Access Compliance Report

Public Rights-of-Way

(Curb Ramps)

Intersection ID: 28762	Main Street: CAMBRIDGE COMMONS DR	Cross Street: COULPORT LN	Location: SW
ADA ID: CB08725919E2	Ramp Type: BlendTrans1	Initial Pass/Fail: Fail	Overall Compliance: No
Severity Score: 10			
Codes/Mitigation Info/Possible Solution		Field Measurements/Component Compliance

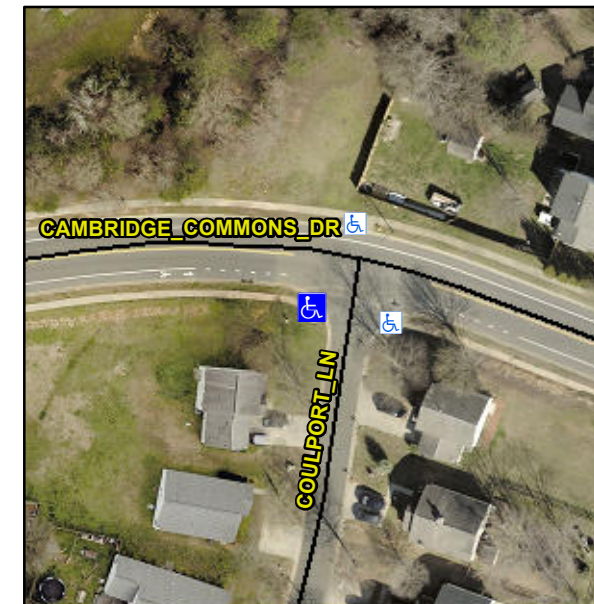
Not Found, R304.5.1, R304.5.3

Compliance	Description	Data	Compliance	Description	Data
N/A	Ramp Length (in)	35.5	Yes	BlendTrans Slope (%)	4.7
No	Ramp Width (in)	41.0	No	BlendTrans XSlope (%)	4.1
N/A	Flare Type LT	N/A	N/A	Flare Type RT	N/A
N/A	Flare Slope LT (%)	N/A	N/A	Flare Slope RT (%)	N/A
N/A	Flare Traversable LT?	N/A	N/A	Flare Traversable RT?	N/A
N/A	Landing Length (in)	N/A	N/A	DWS Provided?	N/A
N/A	Landing Width (in)	N/A	N/A	DWS Contrast?	N/A
N/A	Landing Slope (%)	N/A	N/A	DWS Length (in)	N/A
N/A	Landing X Slope (%)	N/A	N/A	DWS Full Width?	N/A
N/A	Landing Curb? (Y/N)	N/A	N/A	DWS Offset (in)	N/A
N/A	Shared Landing?	N/A			
N/A	Gutter Ponding?	N/A	N/A	Gutter Slope (%)	N/A
N/A	Gutter Lip Ht (in)	N/A	N/A	Gutter X Slope (%)	N/A
N/A	Painted X Walk1?	No	N/A	Painted X Walk2?	No
	X Walk 1 Direction	To E		X Walk 2 Direction	To N
	X Walk 1 Width (in)	N/A		X Walk 2 Width (in)	N/A
	X Walk 1 Slope (%)	0.6		X Walk 2 Slope (%)	0.3
	X Walk 1 X Slope (%)	3.1		X Walk 2 X Slope (%)	1.3

N/A	Ramp inside XWalk1?	N/A	N/A	Ramp inside XWalk2?	N/A
	Road Slope (%)	1.2		Clear Space?	N/A
	Road X Slope (%)	5.0	N/A	Clear Space to XWalk (in)	N/A
N/A	Any Obstructions?	N/A	N/A	Storm Grate/Utility Hazard?	N/A
	Obstruction Type			Storm Grate/Utility Type	
		N/A			N/A
			Yes	Surface Condition? (G/P)	Good
			No	Curb Slope (%)	12.3

Remove & Replace Curb Ramp With Two New Directional Ramps or Equivalent.
